PROPOSED ADDITION TO EX.S.F.R

3248 N.FREDERIC ST. BURBANK, CA 91504

TO: Alfonso Hernandez, Assistant Planner (ext. 5277)

Based on the drawings submitted for this review, the following requirements apply to the project. Additional requirements will be included when complete drawings are submitted for Plan Check. The applicant and/or project designer is responsible for ensuring that all mandatory information required for permit issuance has been addressed on the plans.

1 SITE PLAN

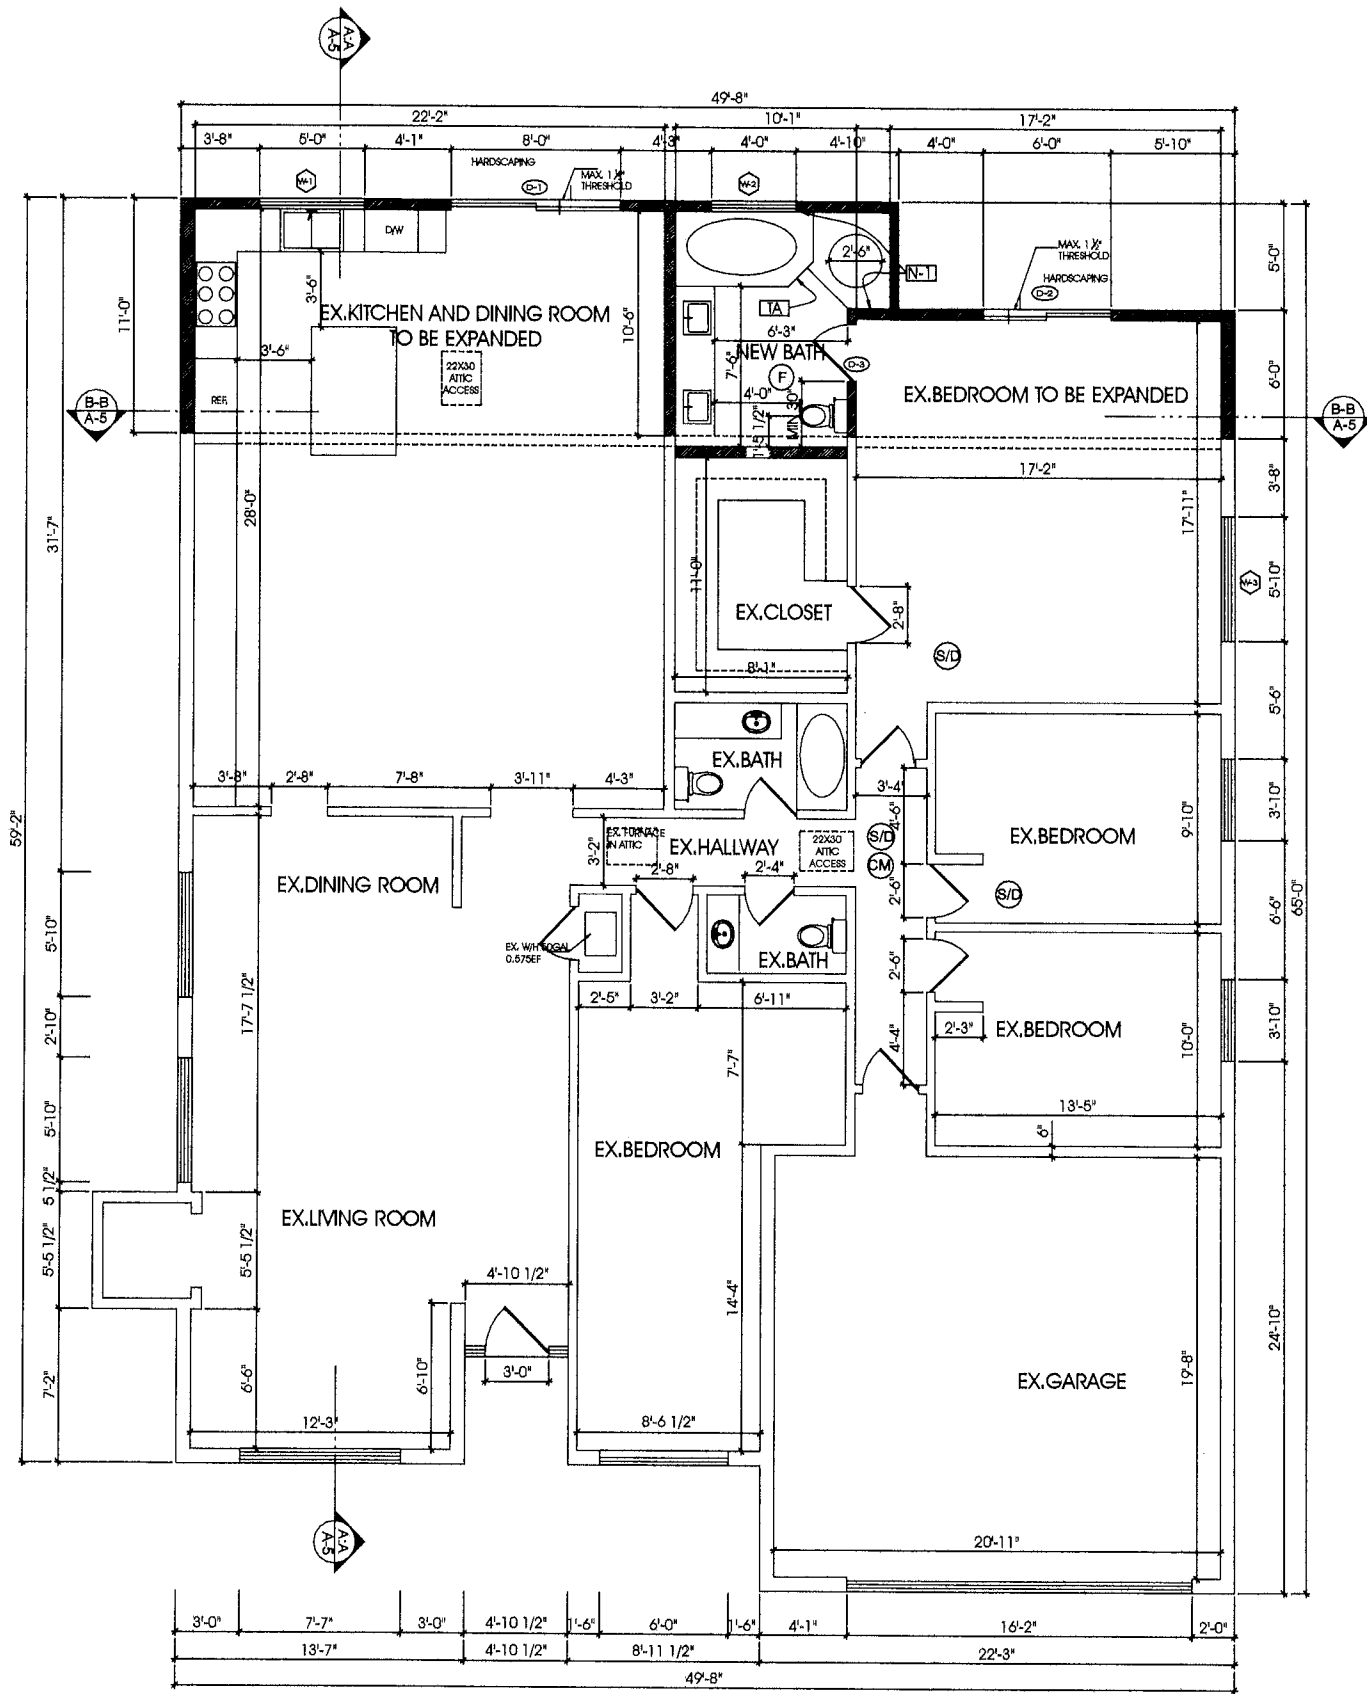
- Land Square Footage, per LA County Assessor, is 11,502 SF
 - Building Square Footage, per LA County Assessor, is 1,862 SF
 - Lot Coverage calculation show 1,862 SF, while F.A.R. is indicated 2,045 SF for dwelling. Please clarify.

- City records show no permits to increase dwelling size from 1,862 SF to the listed 2,045 SF
